# **Fishermans Bend Planning Review Panel**

## **Draft Amendment GC81 in the Fishermans Bend Urban Renewal Area**

STATEMENT TO THE PLANNING PANEL APPOINTED BY THE MINISTER FOR PLANNING FOR  
AMENDMENT GC81 IN THE FISHERMANS BEND URBAN RENEWAL AREA BY CHARMAINE DUNSTAN,  
TRAFFIC ENGINEER

Figure 1: Fishermans Bend Lorimer Precinct (Source: Figure 20 of the Framework)

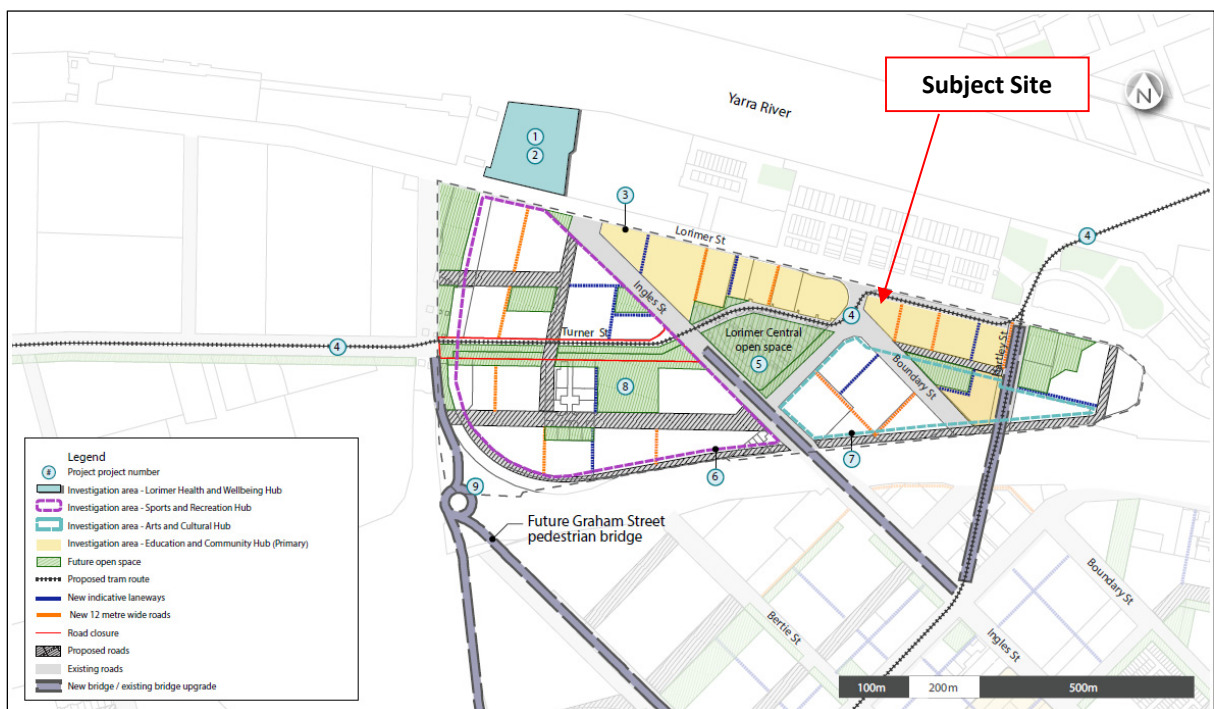
Figure 1 illustrates the detailed precinct plan for Lorimer included in the Framework. As the most recent plan for this area and in many ways the most detailed, I have relied heavily on this plan when forming my opinion. This figure shows:

- The northern tram route running along the south side of Lorimer Street. This appears to show a separate tram fairway outside of the existing Lorimer Street road reserve and road carriageway, although no reservation width is specified in this plan. The tram route extends over the Yarra River at a roughly 45-degree angle and connecting to Hartley Street via Point Park Crescent West. This tram route is identified as a ‘medium term’ project under the Framework, with a delivery timeframe of 2-7 years (2020-2025). It should be noted that this is the only plan in the public documentation that provides a precise route for how the northern tram route transitions between Collins Street and Turner Street. See Section 5 of my report for more commentary on this matter.

- A new 12m wide laneway along the eastern boundary of the subject site. It is not clear from any of the plans or diagrams available, but it appears this laneway is shared with the adjacent property to the east.

- At the south-east corner of the site, a new road connecting Boundary Street to Hartley Street. No road reservation width is specified in this plan.

It appears to me that the intended vehicle access outcome for this site is what is shown in Figure 20 of the Framework Plan (Figure 1 of this report), the construction of a 12m wide north-south laneway between Lorimer Street and intersecting with Boundary Street and the new east-west road link between Boundary Street and Hartley Street.

It is not clear why this north-south laneway is not specified as a road in Map 2 of the proposed controls, it would provide much greater clarity if it was.

- The new north-south laneway will connect to Lorimer Street, where it appears that a separated tram route directly abuts the subject site and separates the laneway from the Lorimer Street main carriageway. This creates a significant conflict point between vehicles entering/exiting the laneway and the tram right-of-way. The approval of access in this form is unlikely in my view due to the separate tram right-of-way.

**Figure 2: Fishermans Bend Public Transport Plan (Source: Figure 5 of the Framework)**

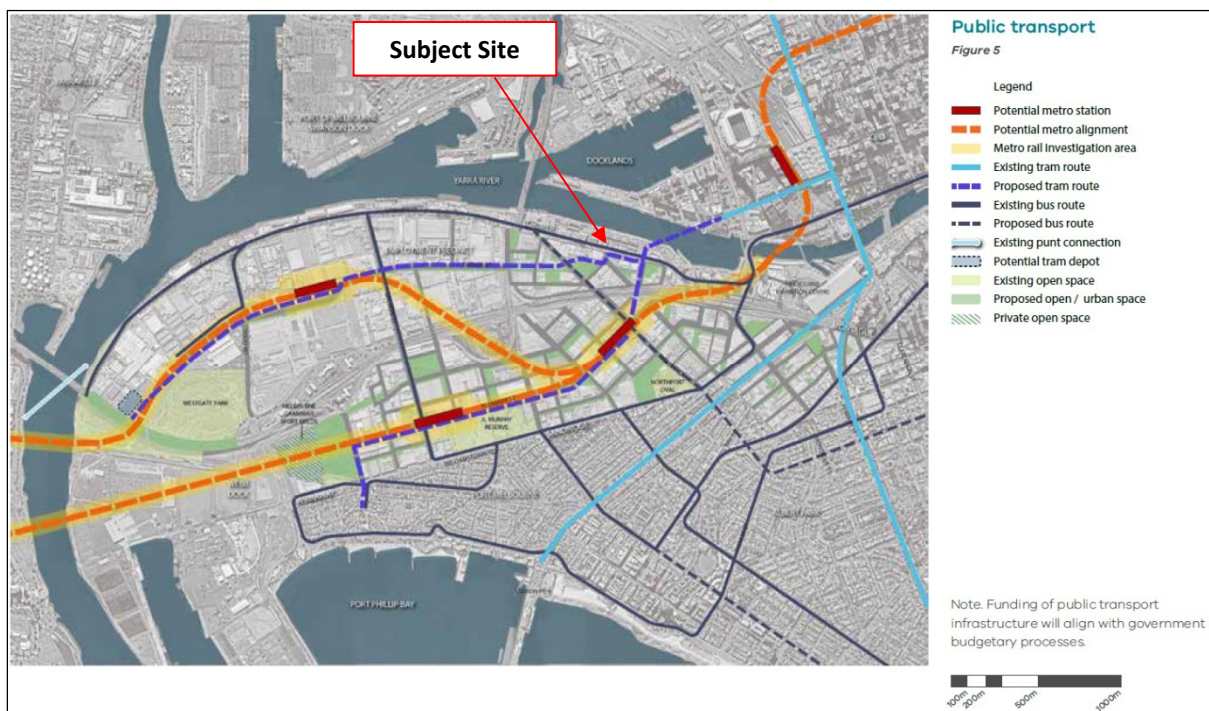
- Figure 2 identifies the public transport network, including the northern tram route running along Lorimer Street. At this level of plan detail, I do not believe the plan is detailed enough to specifically identify if the tram route is intended to travel along the south side of Lorimer Street (as shown at Figure 20 of the ITP). It is clear from the Framework, that the northern tram route and its route through the Lorimer precinct is the key, relatively short-term, public transport link into Fishermans Bend.

**Figure 3: Fishermans Bend Road Network Plan (Source: Figure 8 of the Framework)**

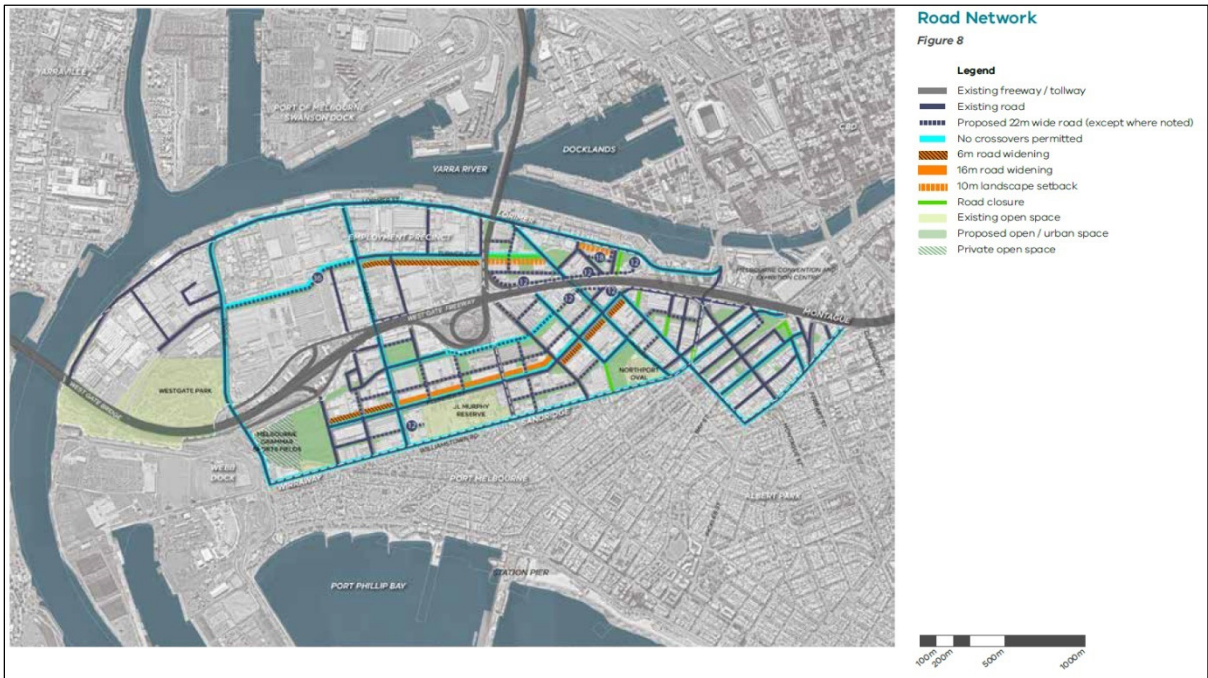
- Figure 3 designates Lorimer Street as a ‘no crossover permitted’ road. It also shows the east-west road linking Boundary Street and Hartley Street.
- Figure 4 illustrates two key off-street cycling routes in close proximity to the site. One is the route running along the new road between Boundary Street and Hartley Street and the other is the ‘active travel link’ which combines with the tram bridge over the Yarra River. It is readily evident that the active travel link over the Yarra, which directly connects to the key east-west strategic cycling routes along Turner Street and Plummer/Fennel Street, is a critical link between for cyclists/pedestrians to/from the CBD.

**Figure 4: Fishermans Bend Cycling Infrastructure (Source: Figure 7 of the Framework)**

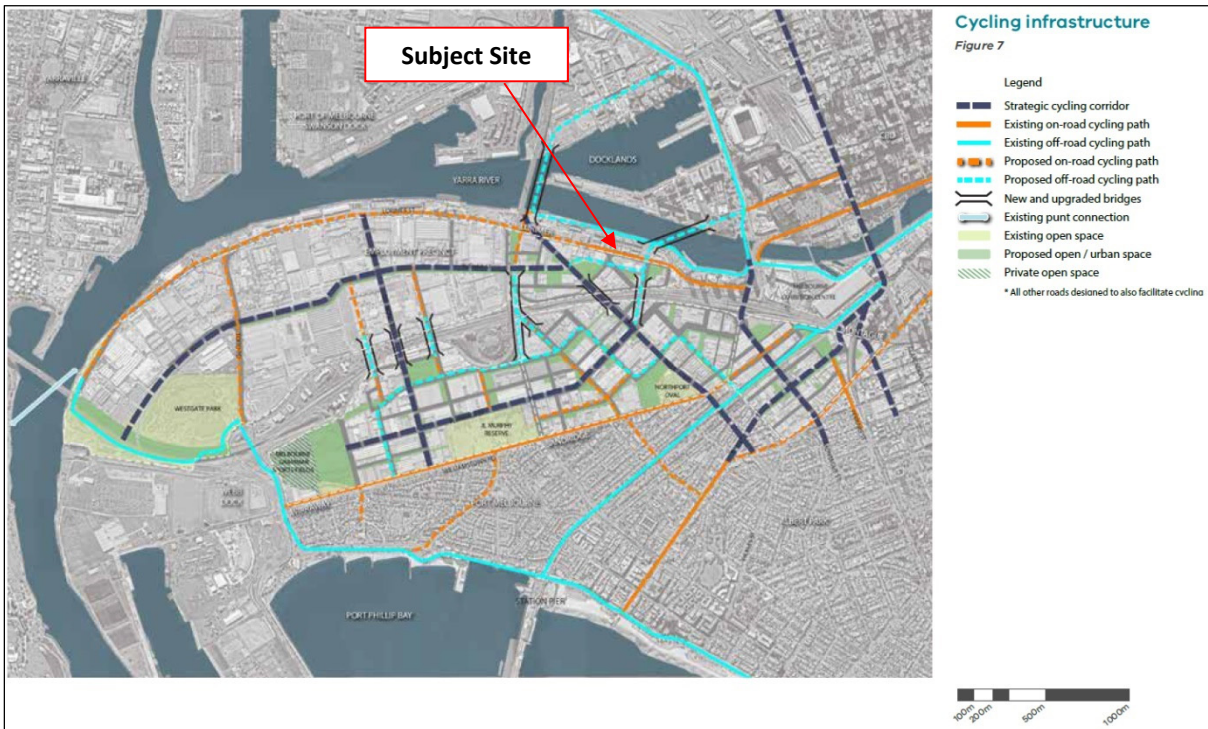
It is not clear to me why these links are not identified as ‘strategic cycling corridors’ under the Framework when they are clearly critical links and identified as ‘strategic cycling corridors’ under the ITP (see Figure 8).

**Figure 5: Fishermans Bend Activity Cores (Source: Figure 13 of the Framework)**

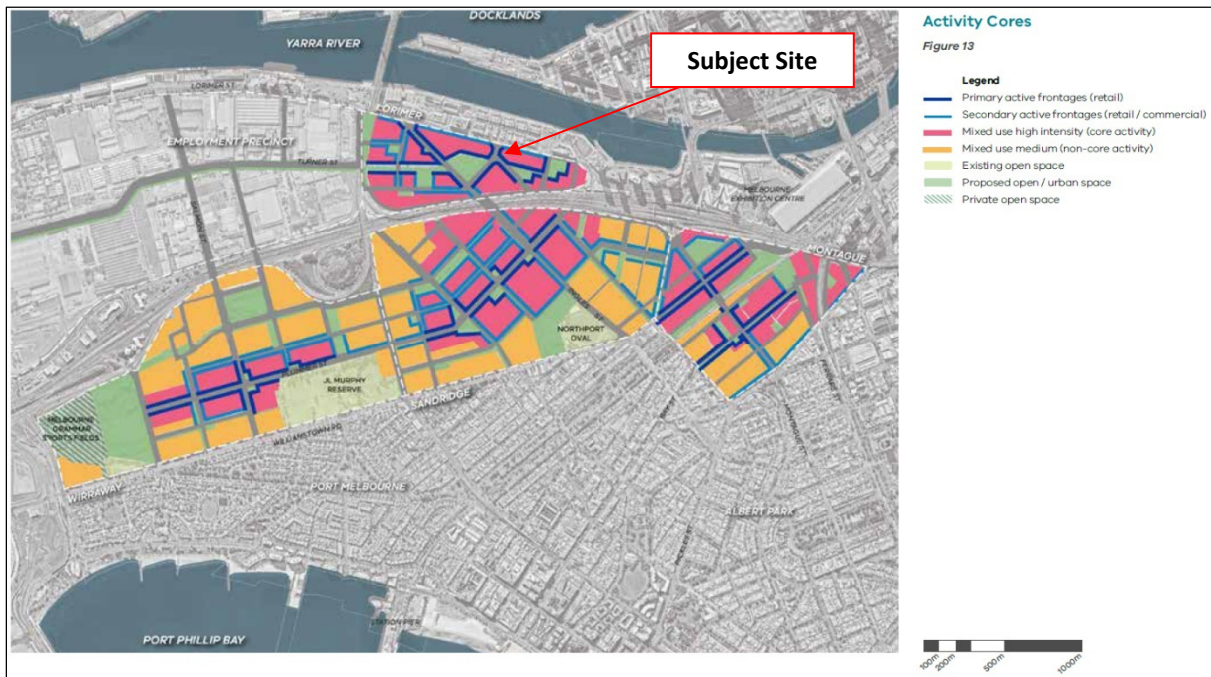
- Figure 5 illustrates that the subject site has designated primary active frontages to Boundary Street and Rogers Street and secondary active frontages to Lorimer Street.

Figure 6: Fishermans Bend Public Transport Plan (Source: Figure 3 of the ITP)

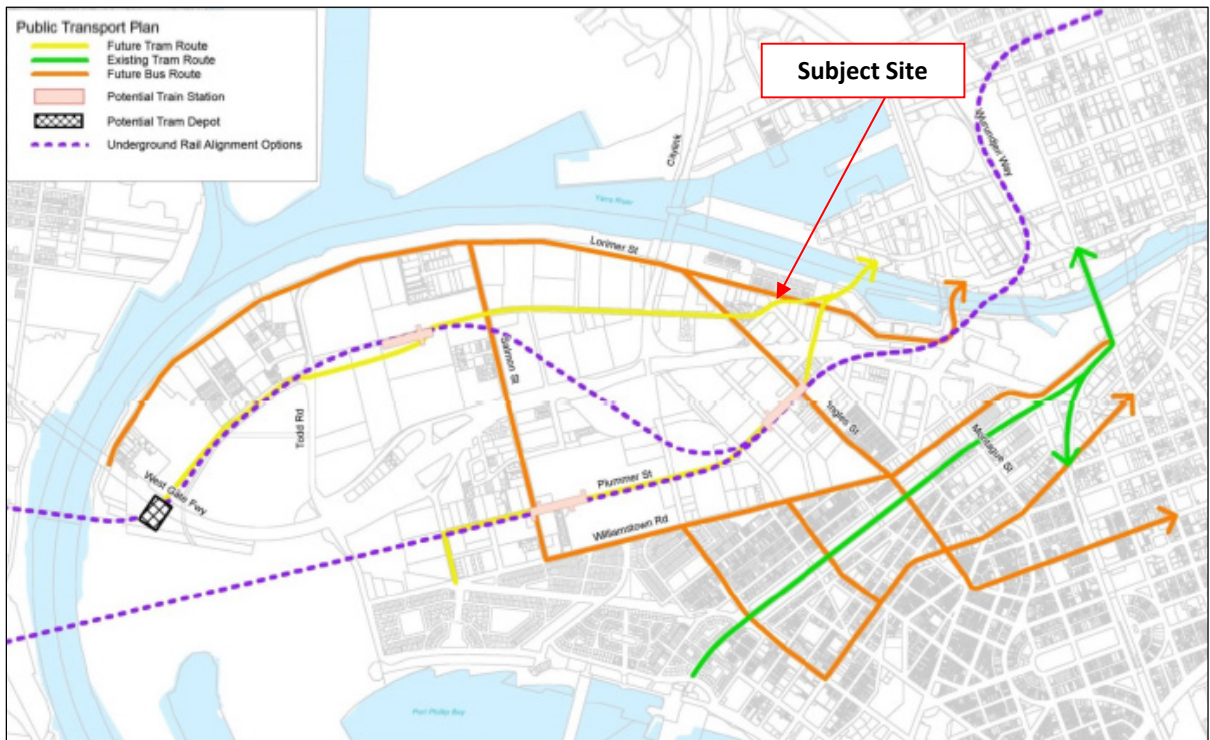
- At Figure 6, the ITP is far less specific about how the northern tram route crosses the Yarra River and transitions between the Yarra and Turner Street, but generally shows a Lorimer Street alignment.

Figure 7: Fishermans Bend Walking Plan (Source: Figure 4 of the ITP)

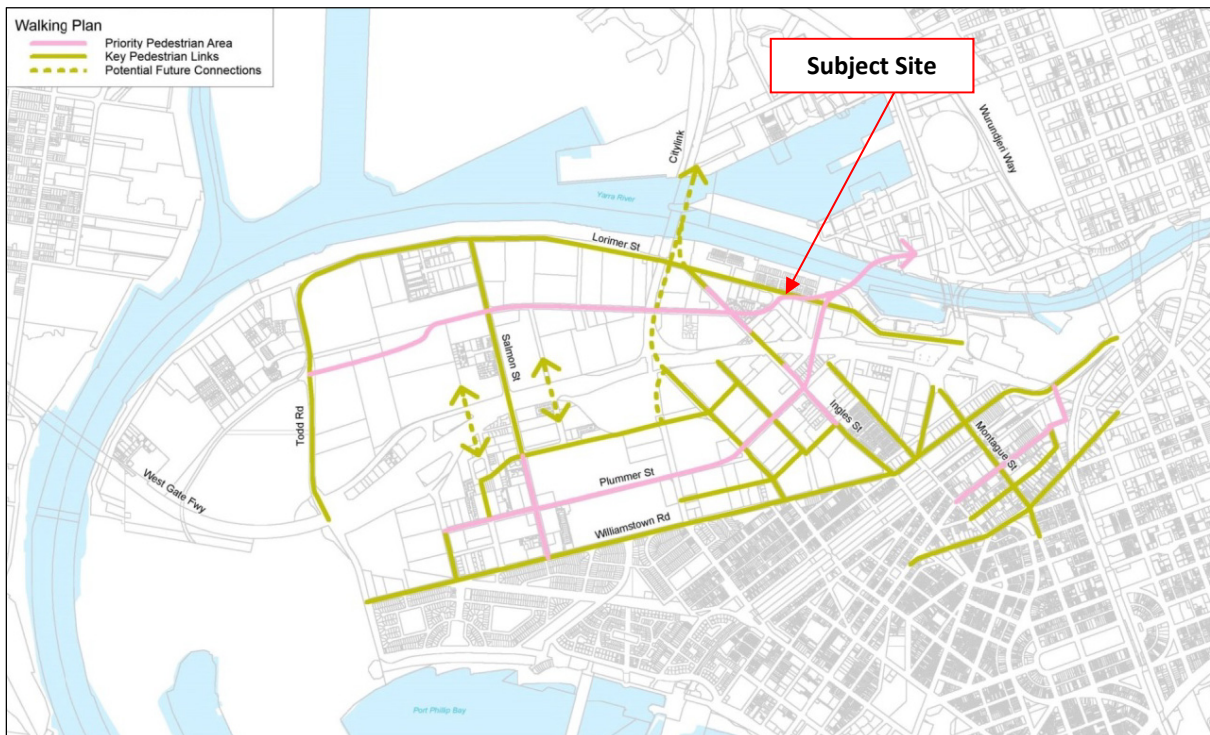
- At Figure 7, the Walking Plan indicates that the site's Lorimer Street frontage will be a 'Priority Pedestrian Area'. This area extends over the 'active transport bridge' across the Yarra. There is not an equivalent 'Walking Plan' in the Framework. This plan would indicate that the site's frontage to Lorimer Street is the key pedestrian link past the subject site (as opposed to Boundary Street and the new east-west road link to Hartley Street).

**Figure 8: Fishermans Bend Cycling Plan (Source: Figure 5 of the ITP)**

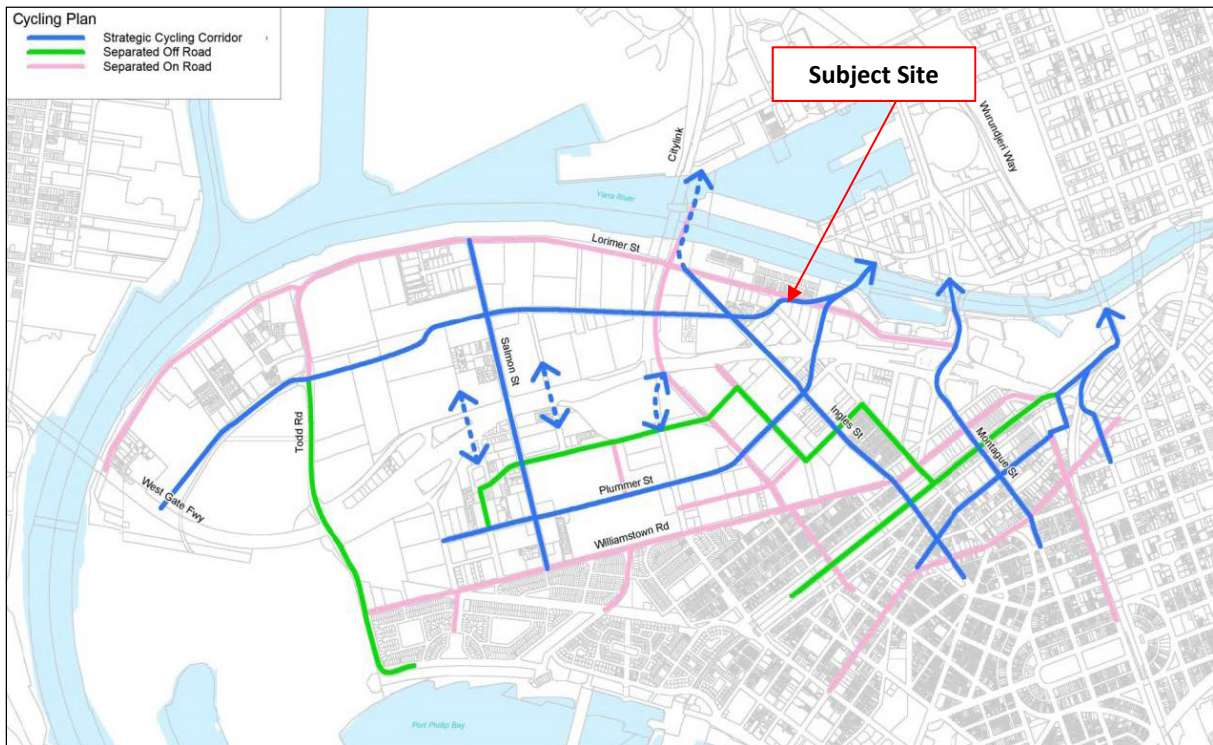
- Figure 8 presents the cycling plan from the ITP and designates that the link between Turner Street and the active travel link over the Yarra as a strategic cycling route. The Framework only designates this route as an off-road cycle path. In my view, the Framework has made a mistake as clearly the connection between Turner Street and the Yarra (and between Plummer/Fennell Street over the Westgate to the Yarra) are key cycling routes connecting Fishermans Bend to the CBD.

The ITP plan is also inconsistent with the Framework in that it shows this cycling link travelling along the south side of Lorimer Street, instead of along the new east-west road link between Boundary Street and Hartley Street.

**Figure 9: Map 1 core areas and active frontages (Source: Exhibited Clause 37.04 – Schedule 4 of Melbourne Planning Scheme)**

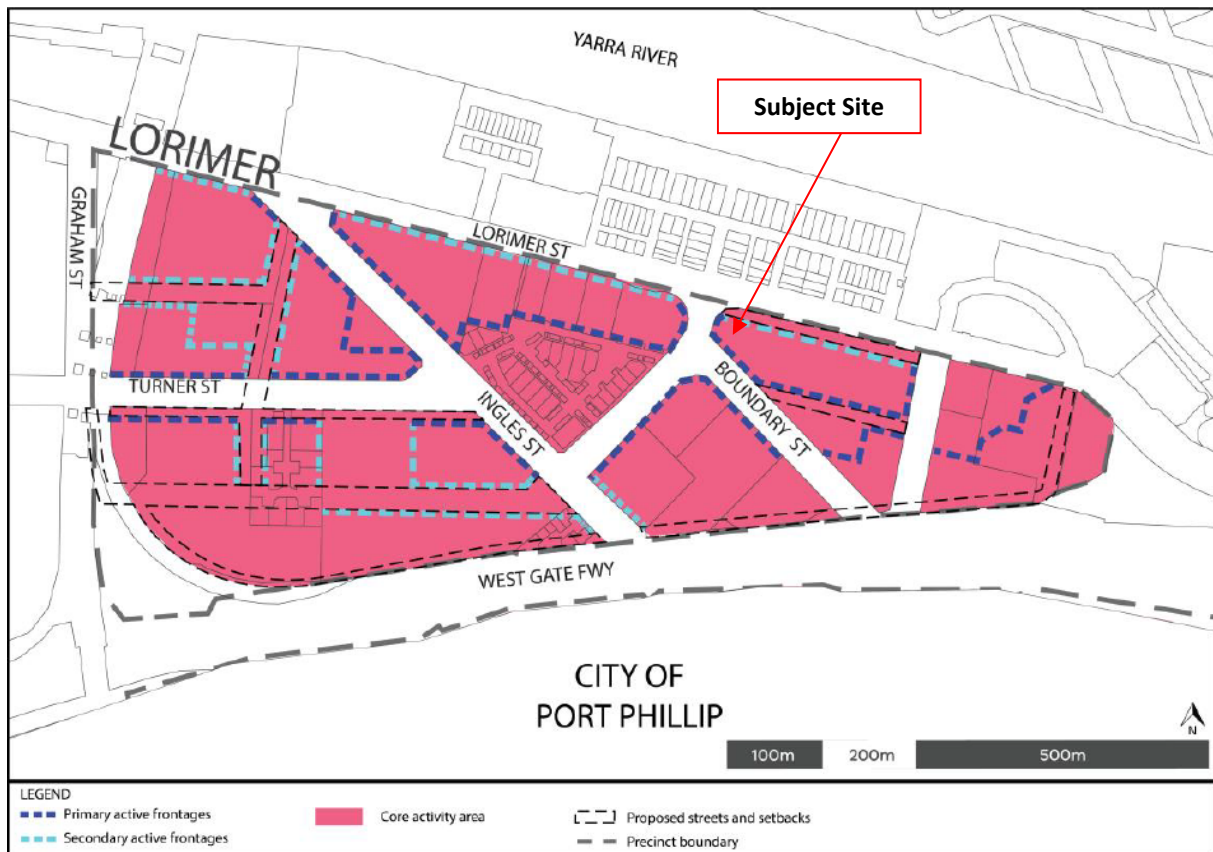
Figure 9 is a picture of Map 1 from the Schedule and is generally consistent with the Framework. It illustrates that Rogers Street/Boundary Street and the new east-west road link between Boundary Street and Hartley Street as being 'Primary Active Frontages' and Lorimer Street as being a 'Secondary Active Frontage'.

Figure 10: Map 2 Street and laneway layout (Source: Exhibited Clause 37.04 – Schedule 4 of Melbourne Planning Scheme)

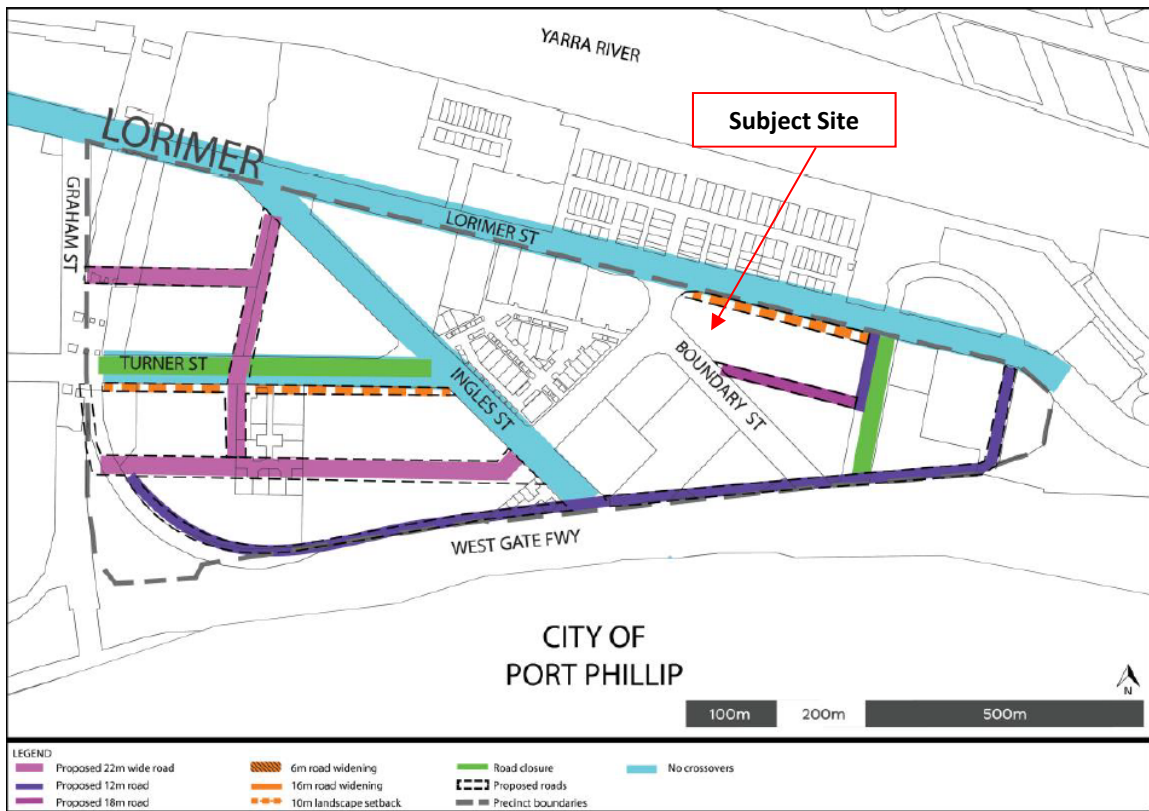
Figure 10 is a picture of Map 2 from the Schedule, the proposed street and laneway layout. Of key importance are the following:

- Lorimer Street is defined as a 'No Crossover' street under the controls, which is consistent with the Framework.
- Along the subject site's Lorimer Street frontage, there is a '10m wide landscape setback', which is also designated as a 'proposed road'. This is inconsistent with the Framework which illustrates the northern tram route within this space. There is a significant difference between a landscaping setback (which presumably can be built under and retained in private ownership and not transferred to public ownership) and a public road reserve (or tram reserve). If the 10m landscape setback is used for the tram right-of-way, approximately 7m of the 10m wide strip will be devoted to tram tracks, not landscaping, resulting in a tram carriageway close to the boundary of the site.

- This map does not show the 12m wide laneway on the site's eastern boundary proposed under the Framework plans (or any other laneways between Lorimer Street and the new east-west road between Boundary Street and Hartley Street). As set out in the following sections, the provision of this laneway appears critical to the intent of the controls about how vehicle access to the subject site is to be facilitated.

- The map gives no indication of how the northern tram will be provided or protected. Specifically, how the tram route transitions between the Yarra and Turner Street. This includes not allowing for a 'transport' connection between Rogers Street and Ingles Street.
